# Certificate of Appropriateness

**Property** 3001 W. MCKINLEY Cold Spring Park Historic District  
**Description of work** Applicant will build new two-car garage at the rear of his property.  
**Date issued** 9/16/2022 PTS ID 115325 COA Demolish old garage build new garage

3001 W. McKinley Boulevard

New Garage will look like this one built at 124 W. Lloyd in 2012.

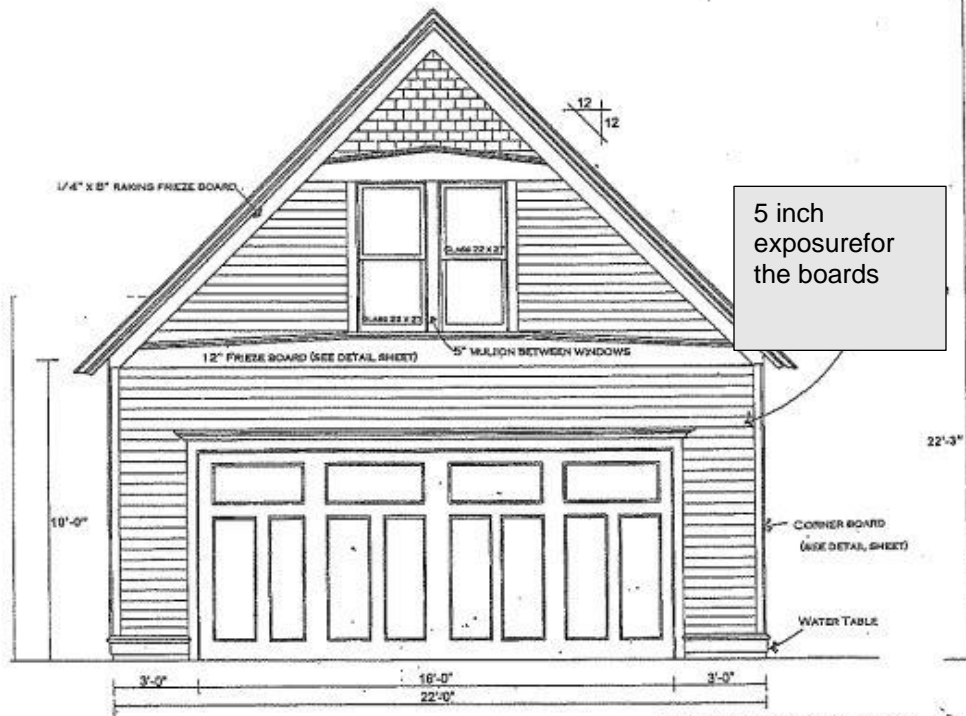
The wood species is important. The details of the garage are important as well: 12/12 roof pitch, 1/4 inch by 5 inch raking frieze board, corner boards, water table, wood widow in gable, 10-ft tall side walls

5 inch exposure for the boards

FRONT ELEVATION

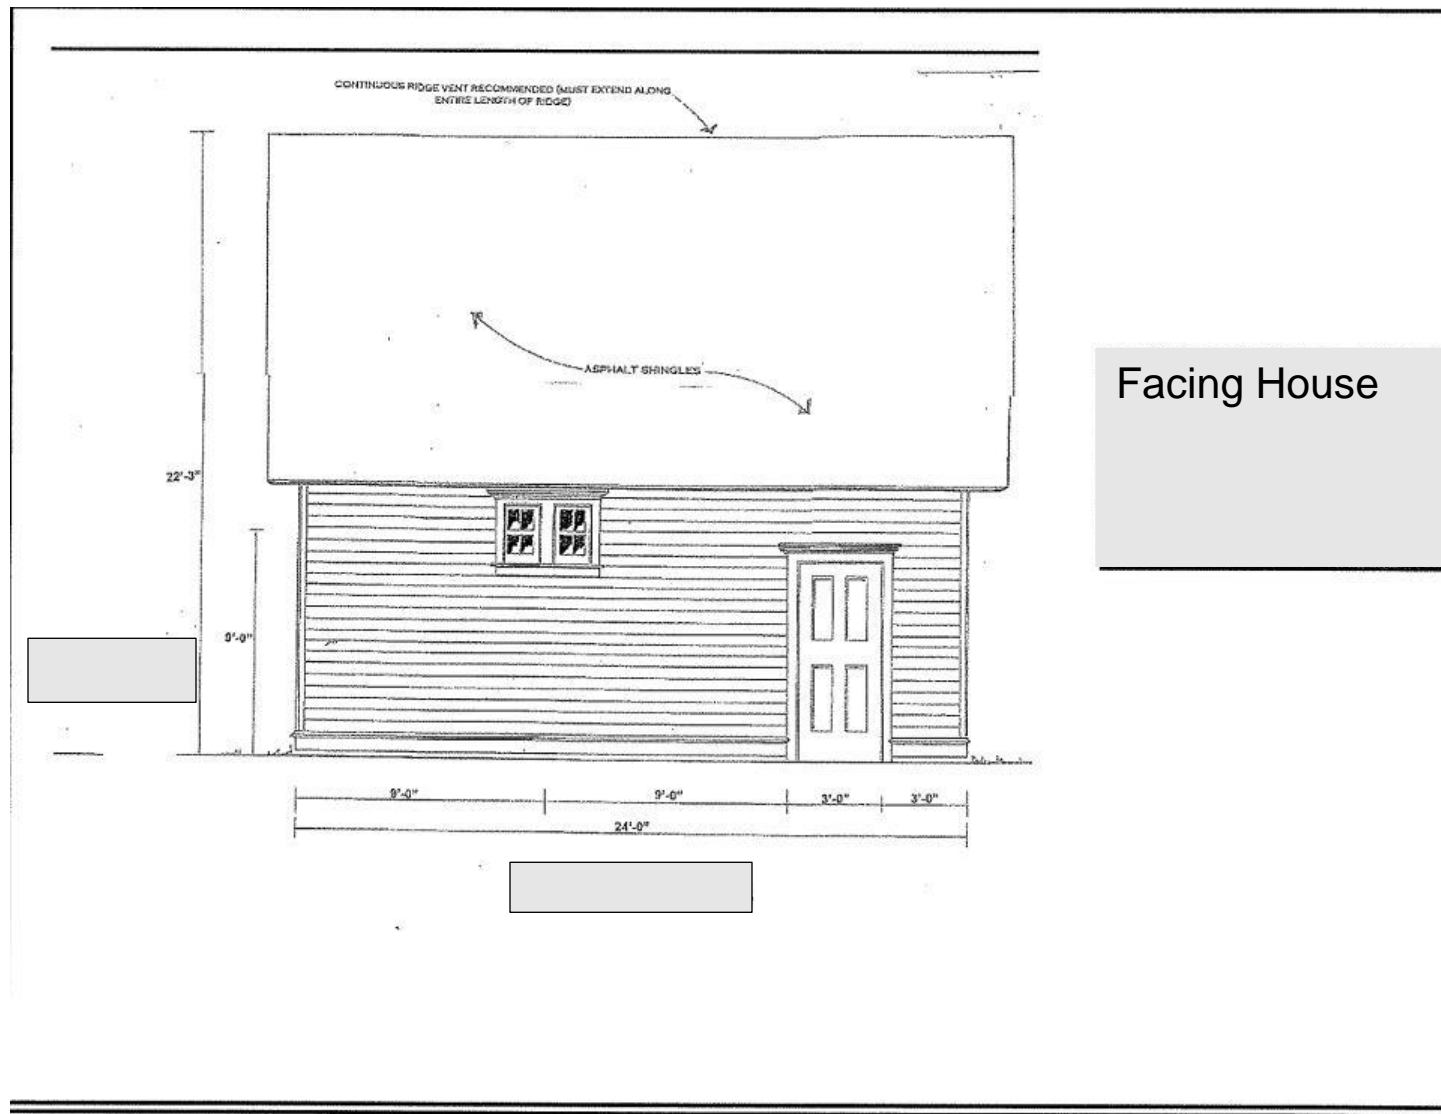
UPWARD-ACTING GARAGE DOORS MADE TO LOOK LIKE SWINGING OR SLIDING CARRIAGE BARN DOORS. MANY DIFFERENT COMPATIBLE DESIGNS ARE AVAILABLE FROM LOCAL RETAILERS

REAR ELEVATION

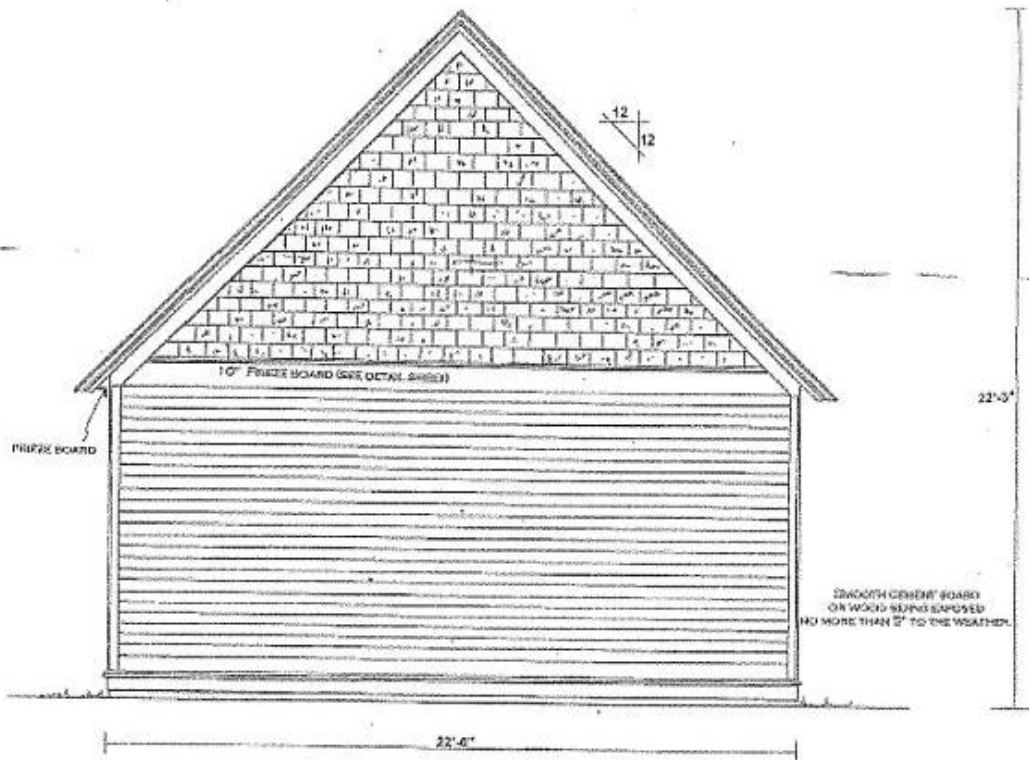
CLAYBOARDS THAT LAST LONGER,  
HOLD PAINT BETTER AND LOOK BETTER  
THAN CEDAR SIDING. SEE  
[WWW.WARDCLAYBOARD.COM](http://WWW.WARDCLAYBOARD.COM) FOR  
INFORMATION ON THIS PRODUCT.

**Frieze board section**

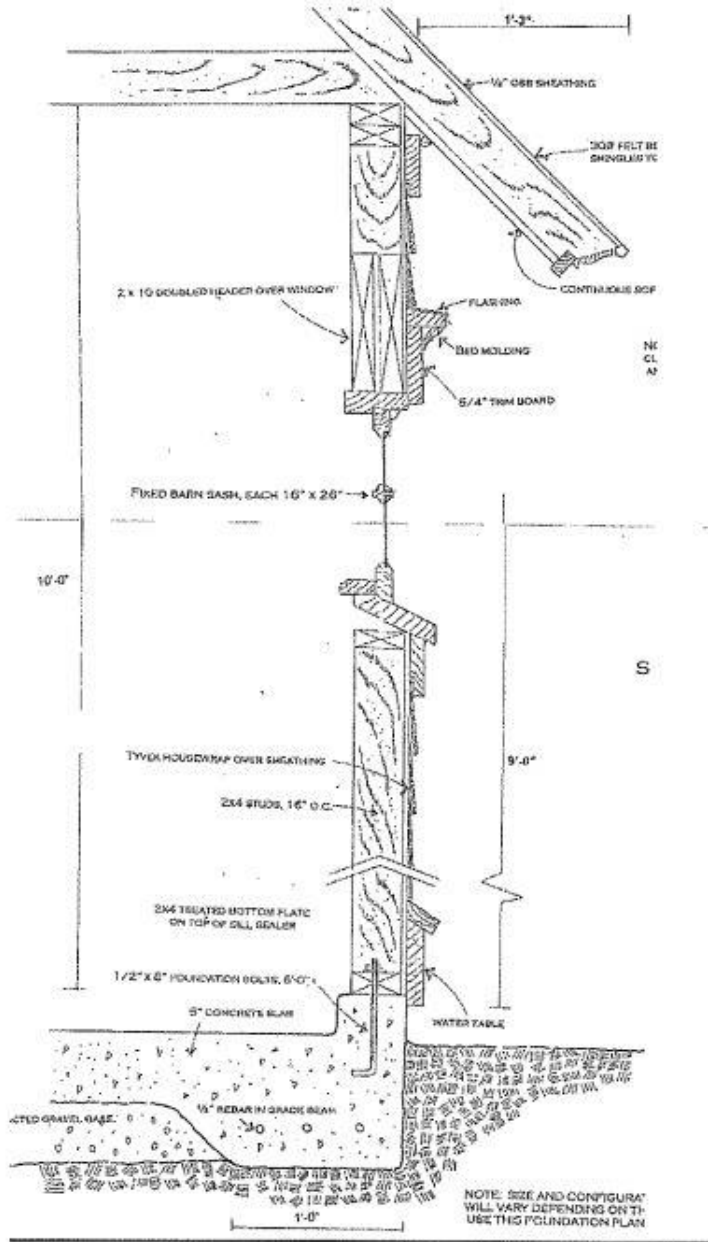
LEVEL FRIEZE BOARD  
IN FRONT AND REAR TABLES  
FULL SIZE

WATER TABLE  
AT TOP OF FOUNDATION

**Options for corner boards, select one**

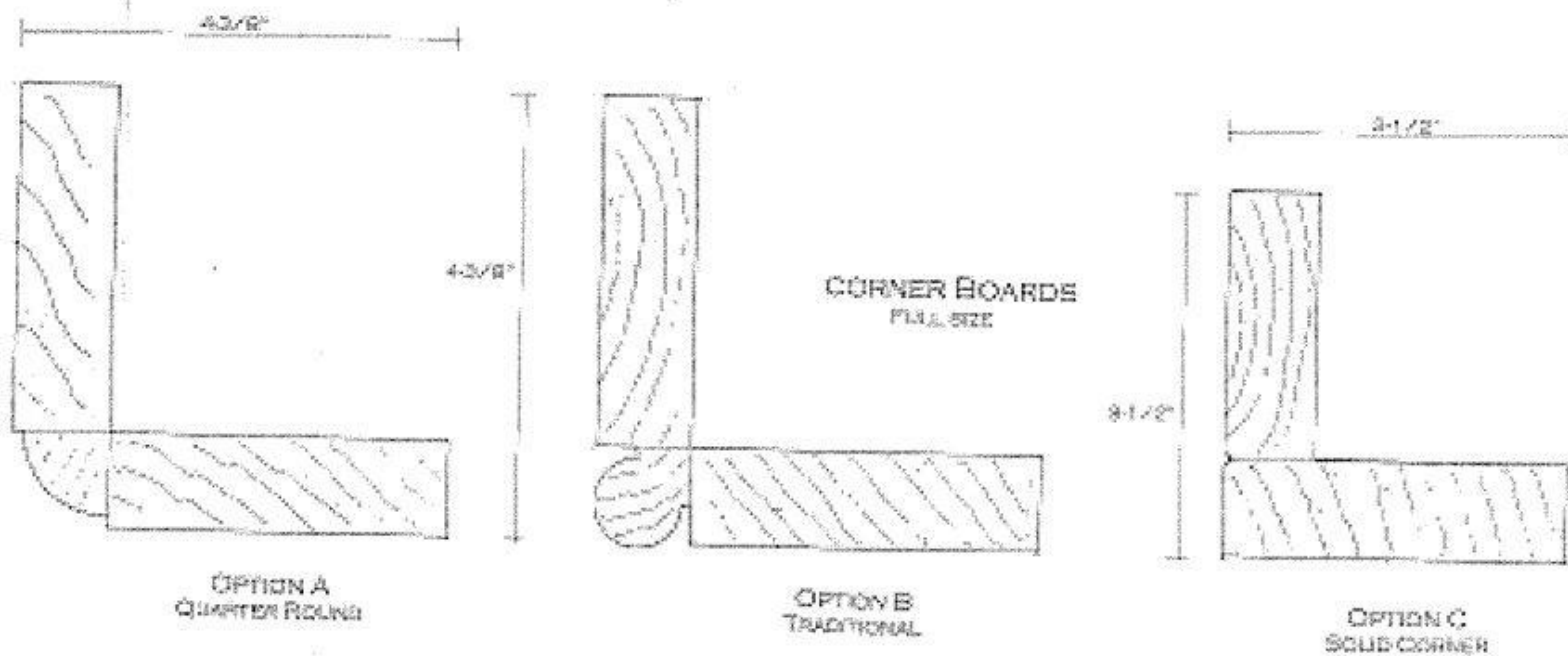
CORNER BOARDS GENERALLY NEED TO BE 3/4" IN THICKNESS IN ORDER TO PROPERLY FINISH CEMENT BOARD BACKING ON WOOD BEAMS. HOWEVER, BECAUSE CEMENT BOARD TENDS TO BE THINNER THAN WOOD, IT IS POSSIBLE THAT STANDARD 1 3/16" CEMENT BOARD MATERIAL MAY BE COMPATIBLE WITH CEMENT BOARD.

NOTE: OPTIONS A AND B GENERALLY IMPROVE CONSTRUCTION AND PRODUCE A BETTER FINISHED APPEARANCE.
